**Before the Planning & Zoning Commission
Meeting of 26 JANUARY 2016**

BUSINESS ITEM NO. 1 STAFF REPORT

File(s): SUB 666-15

Red Hawk Subdivision No. 2 (hereinafter the "Development"; alternatively, "Red Hawk Subdivision No. 2")

PLAT SHOWING Red Hawk Subdivision No. 2

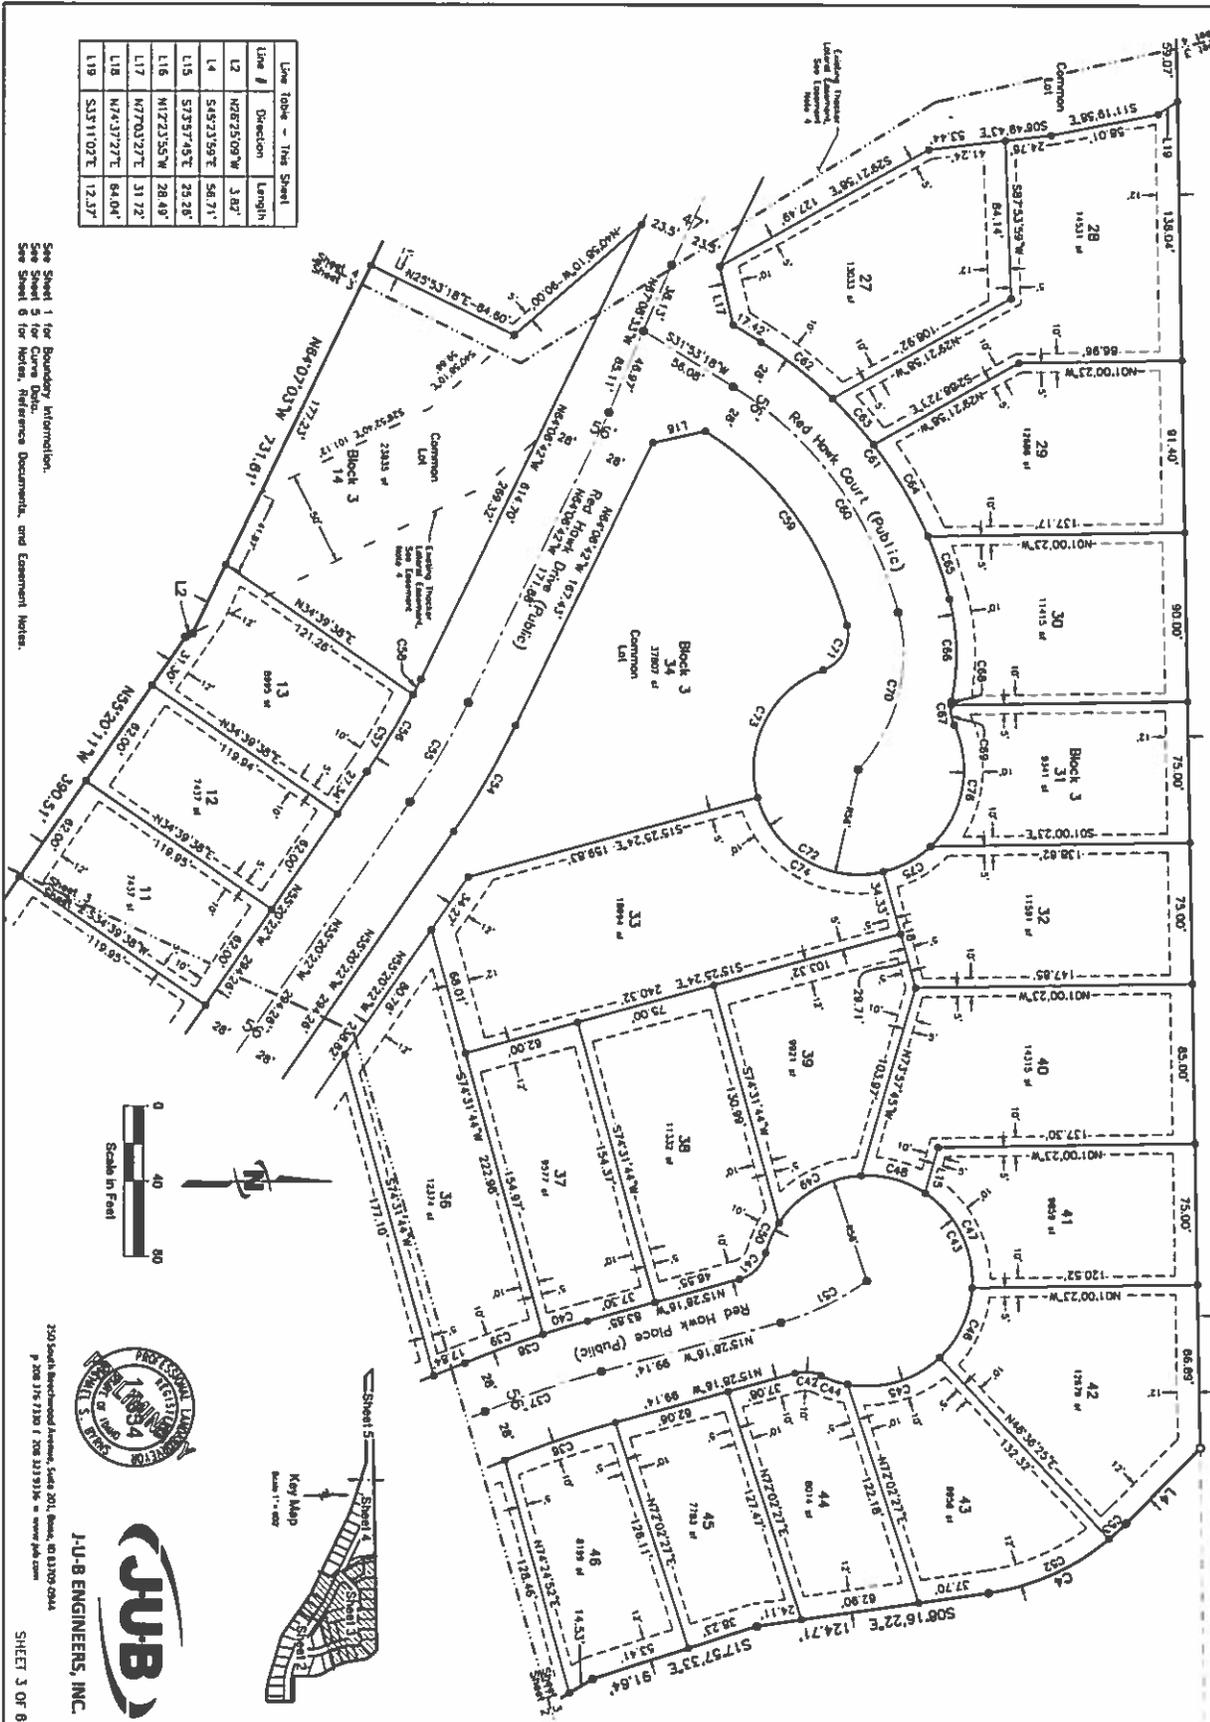
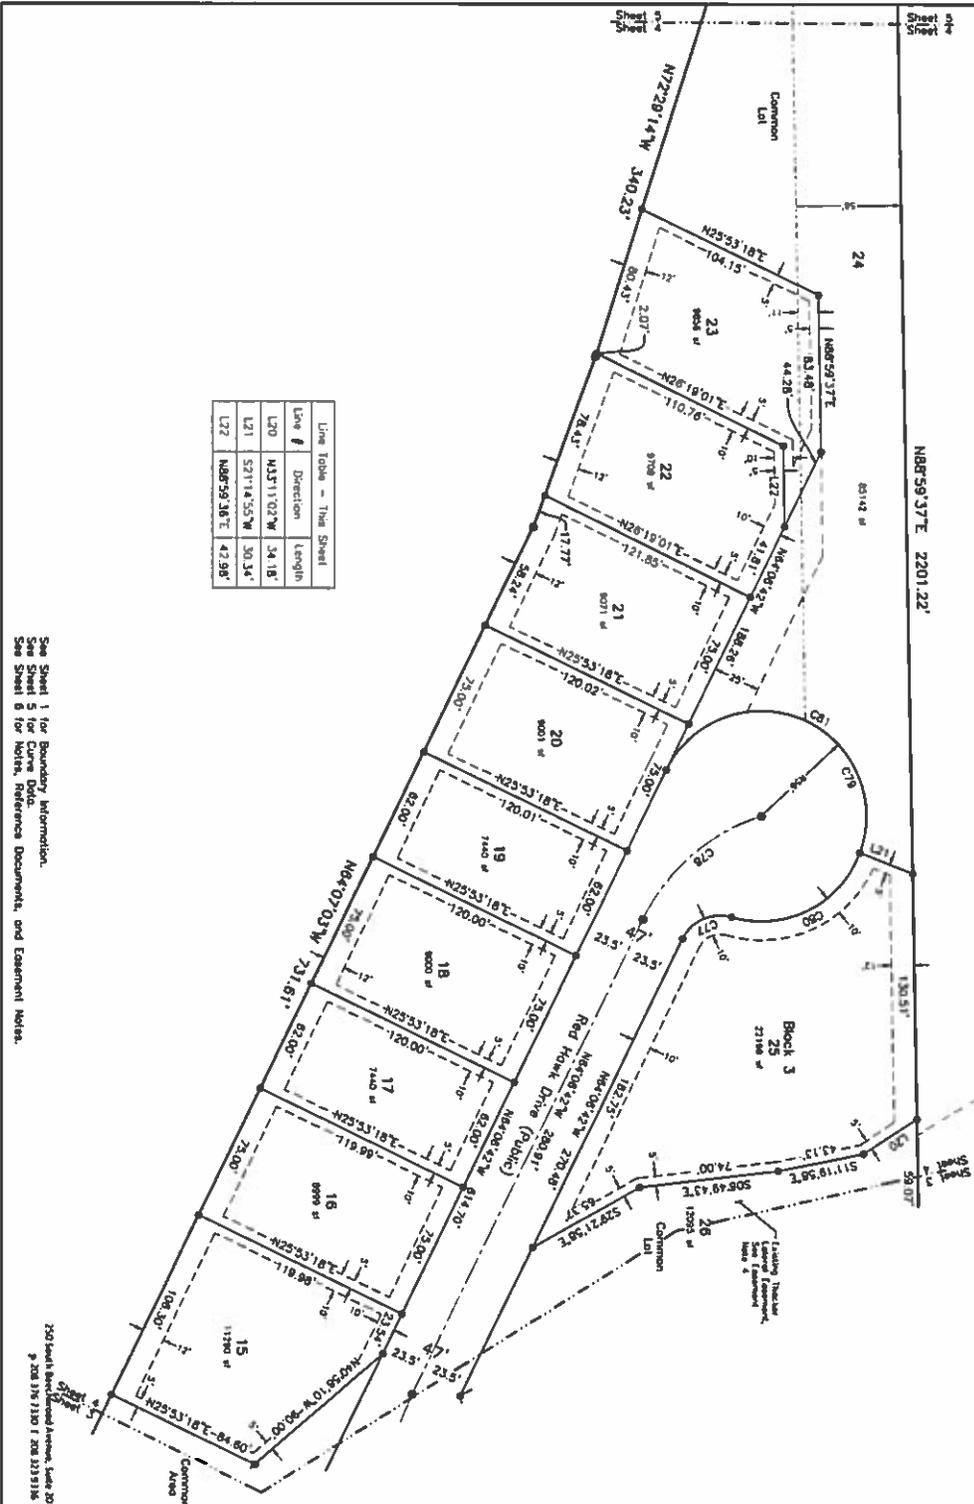
- Propose new, unique street name for Red Hawk Ct to the Engineering Division. Per Canyon County Code 06-05-13 (1) *There shall be no duplication of street names by sound or spelling within Canyon County including within the incorporated areas.* Refer to Street Naming and Addressing Policy in the Engineering Process and Policy Manual (rev 9/2012).
 - Red Hawk Ct street type should be Pl
 - The predirectional should be S
- Red Hawk Pl should be S Red Hawk Pl
- Red Hawk Dr should be W Red Hawk Dr
- Existing road Middleton should be S Middleton Rd on recorded plat (correct predirectional and spellings)
- Include areas of all individual lots, in square feet, listed in lot and/or table.
